STAFF REPORT

RE: Cove at Kettlestone Lot 3 – Site Plan

DATE: February 28, 2017

ABOVE: Aerial of the site plan (outlined in **RED**) in relation to the surrounding properties.

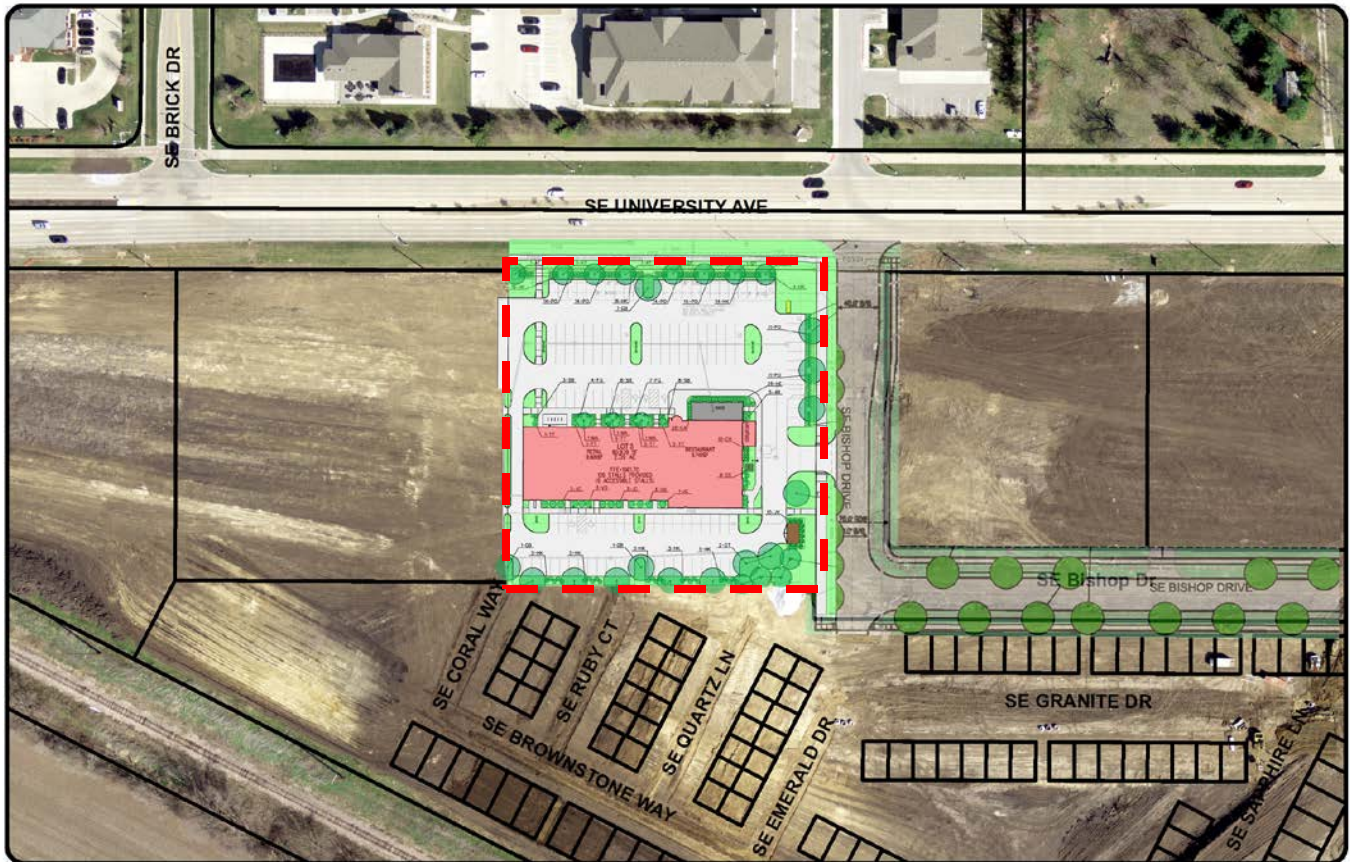
The proposed project includes the construction of a 15,540 square foot multi-tenant commercial building, associated parking, trash enclosure, and site utilities. The site plan identifies the building having a 9,800 square foot retail portion and 5,740 square foot restaurant portion of the building. An outdoor patio is also identified on the front of the building for the use of the restaurant. The trash enclosure is indicated on the east side of the site south of the entrance into the site.

Access to the site will be provided on the east side of the site from SE Bishop Drive, a public street. The applicant also owns Lot 2 to the west with the intent of constructing a similar building on that site. When development of Lot 2 occurs a secondary access will be provided from SE University Avenue. The future access off of SE University Avenue will be an un-signalized full access. The current Capital Improvements Plan (CIP) identifies this location as a potential traffic signal project in the future, however, it does not identify a fiscal year for the project to be completed.

A total of 127 parking spaces are required for this facility. The total amount of parking proposed is 127 spaces (including 6 handicap accessible stalls). The site plan also identifies 5 bicycle parking spaces. The bike rack is located along the northwest side of the building.

As part of the improvements to the site a 5 foot sidewalk will be extended along SE University Avenue and a 10 foot trail will be extended along SE Bishop Drive on the east side of the site. Pedestrian connections into the site from these paths have been indicated on the site plan.

All utilities will be extended to the subject property with current plat improvements. Storm water detention will be provided in the temporary detention basin located on the property to the west of Grand Prairie Parkway, which will eventually be detained in a future regional storm water retention basin.

A minimum of 15% of the project area is required to be open space and the site plan indicates that 26.3% open space will be provided. Landscaping has been provided in compliance with the required planting requirements.

The proposed building will be constructed of a variety of materials including brick, storefront glazing, and simulated wood panels (fiber cement). Galvanized steel mesh will be utilized on the east side of the building to screen mechanical equipment. Per the adopted Planned Development Agreement for the property, 30% of the street facing façade at pedestrian level shall be fenestration, 32% fenestration is proposed. The proposed elevations meet the intent of both the Site Plan Ordinance as well as the Planned Development Agreement. Material samples will be available for review at the Planning & Zoning Commission meeting.

The applicant has submitted a photometric plan and associated light fixture cut sheets. The photometric plan and fixtures meet the requirements outlined within the Planned Development Agreement and the Site Plan Ordinance.

At this time staff is comfortable with the site plan and would recommend approval of the site plan subject to remaining staff comments.
